CITY PLAN COMMISSION STAFF REPORT

CD-CPC-2025-00133

Executive Park Lot 6 Major Amendment

Rezoning to UR - Major Amendment

SHEET TITLE
LANDSCAPE PLAN

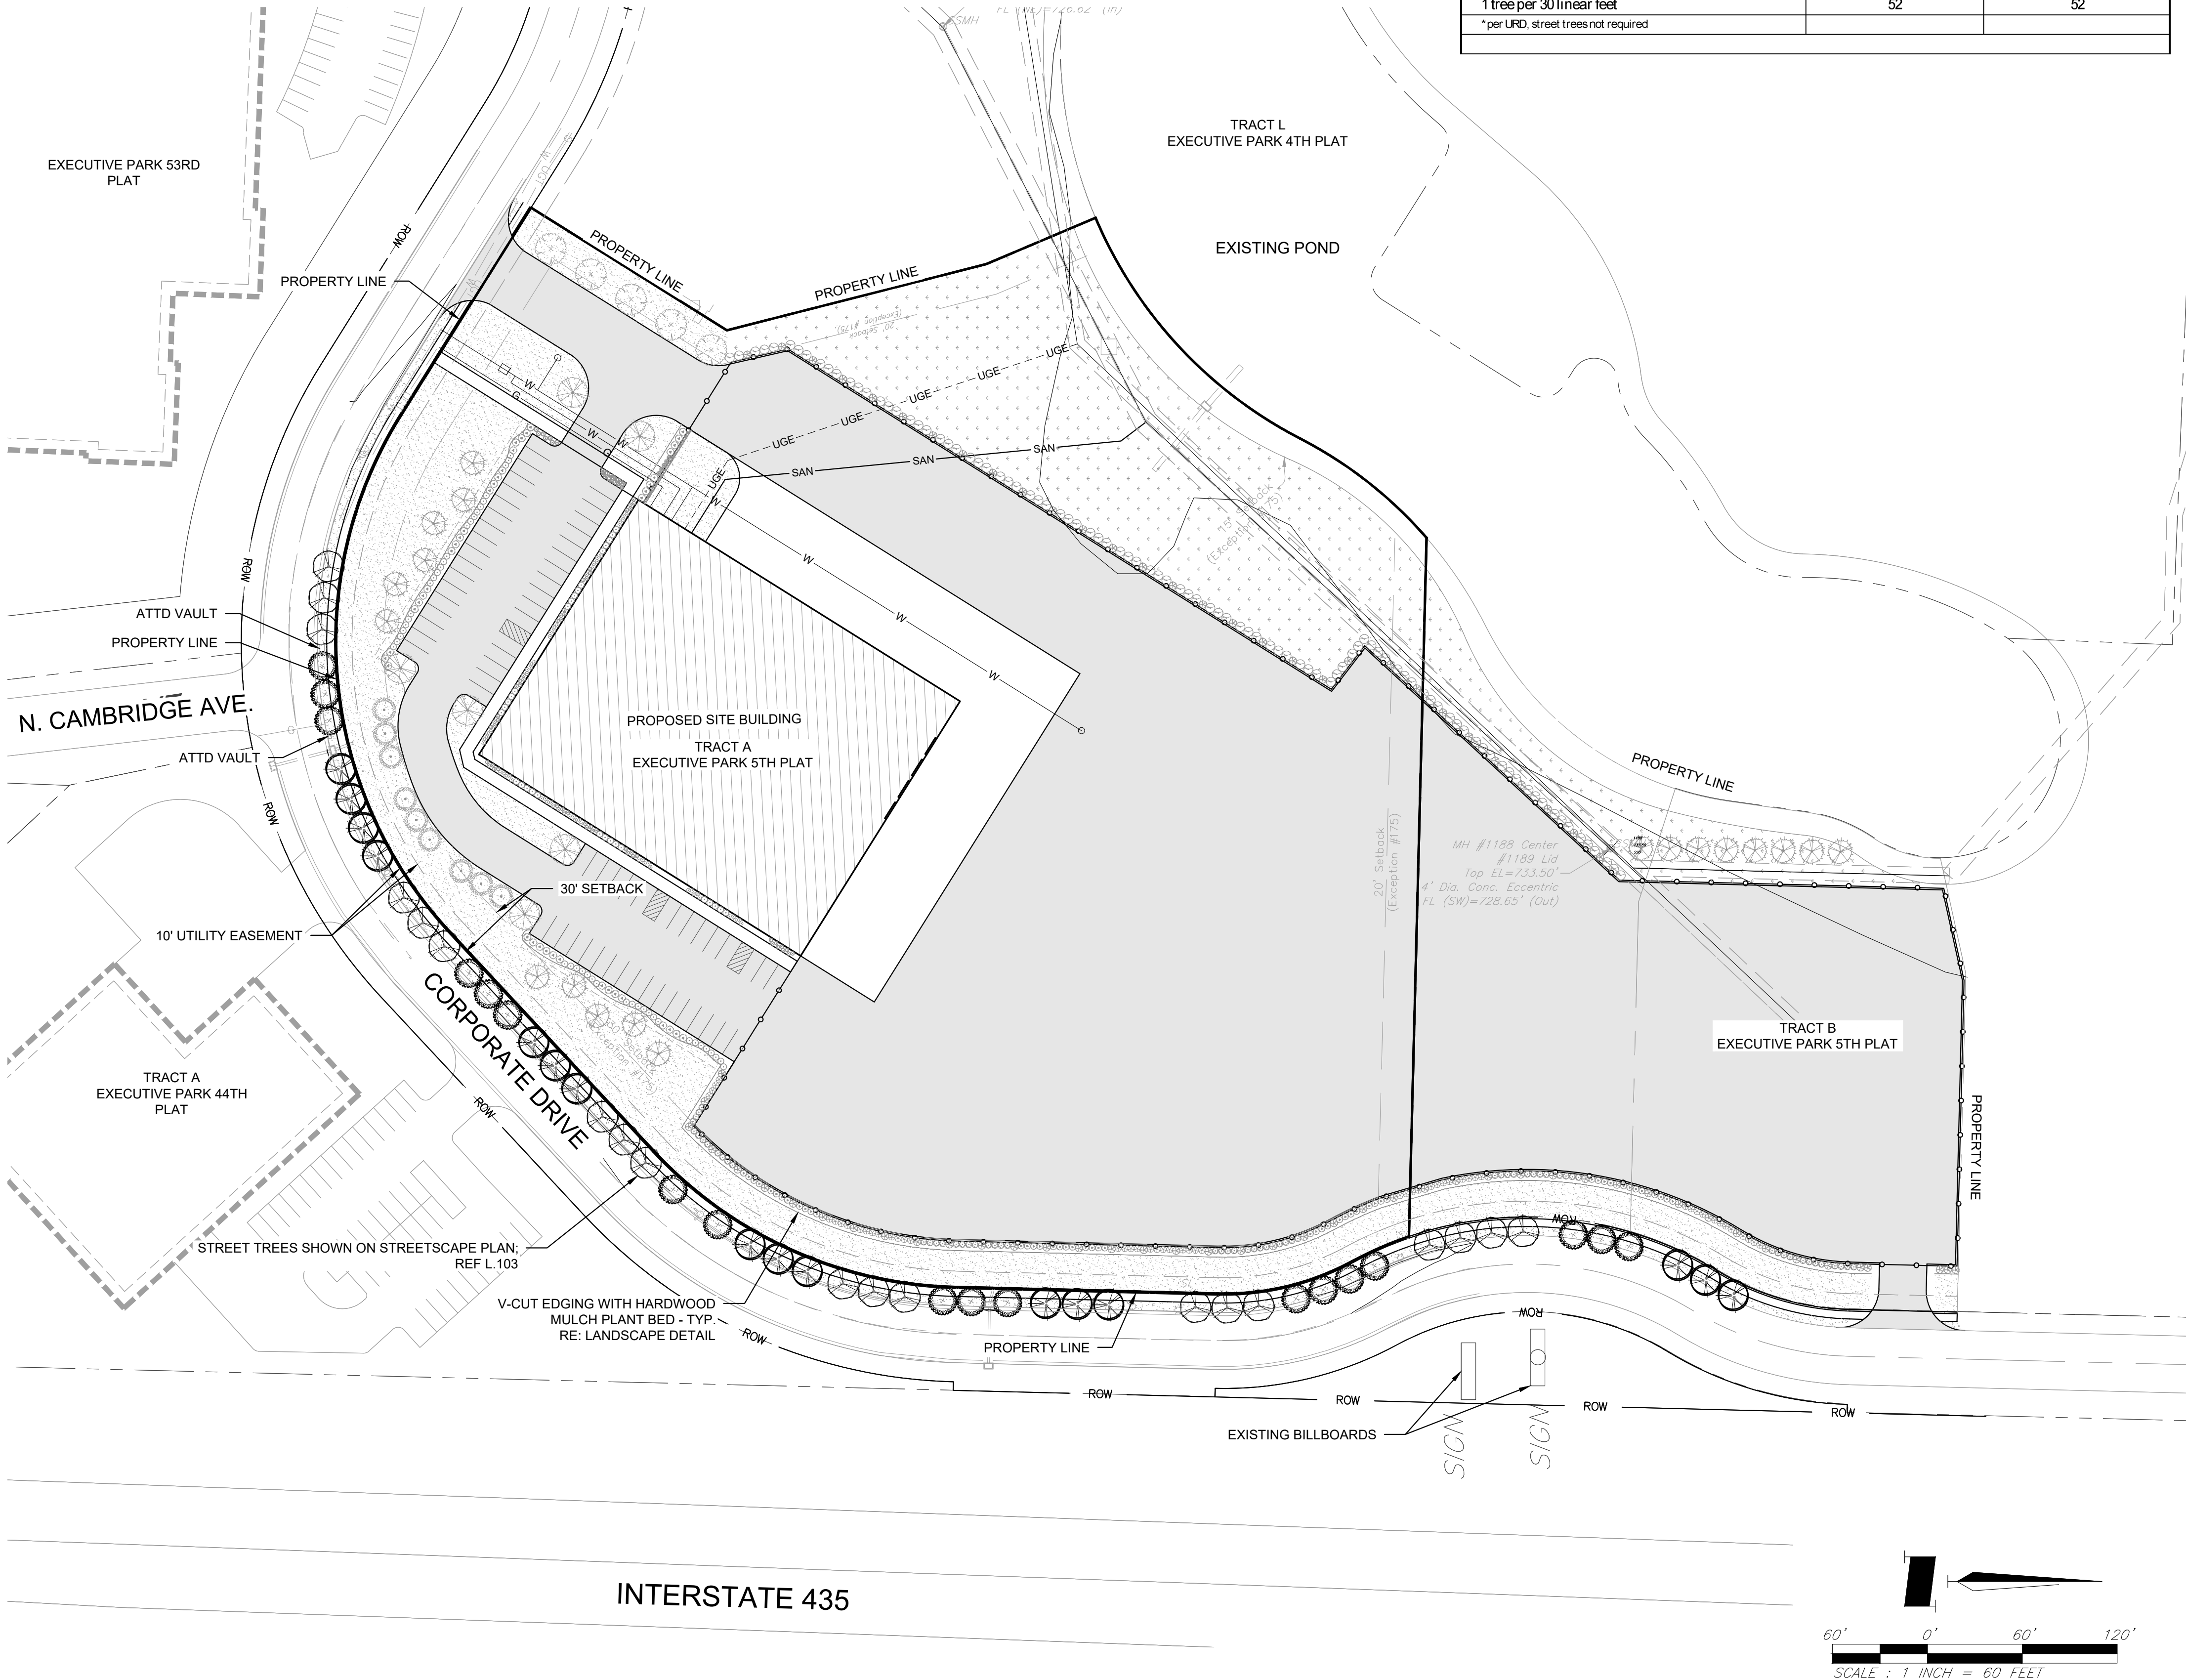
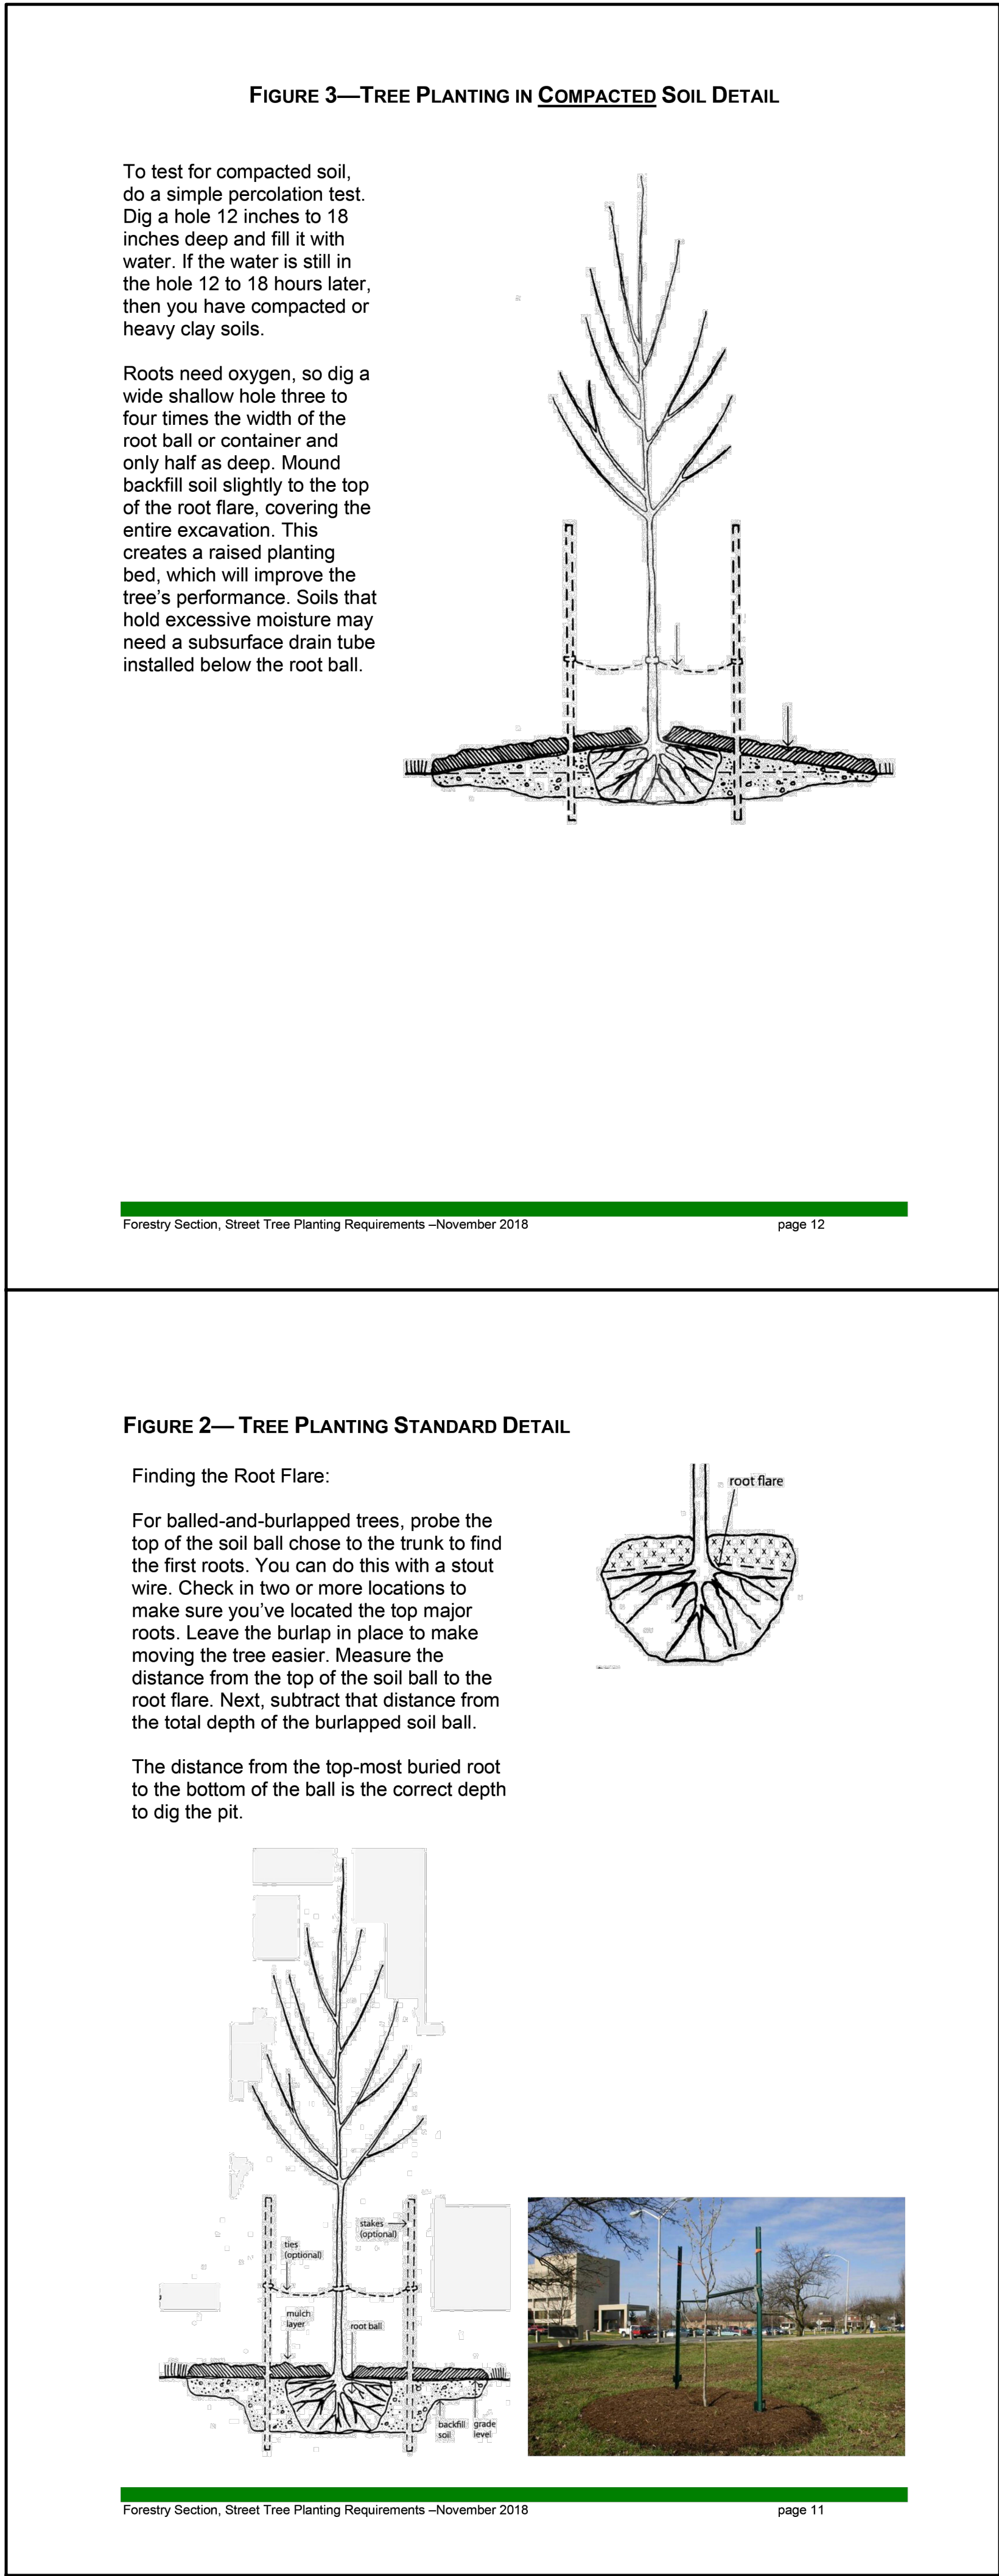
The applicant worked with staff to provide appropriate landscaping throughout the site. The applicant will be required to work with the Police Department prior to ordinance request regarding a remaining correction on the submitted photometric plan.

2. Identify the maximum height of plantings in close proximity to lighting elements. The mature height of these planting shall not impact or lessen the foot-candles shown on the approved photometric plan.
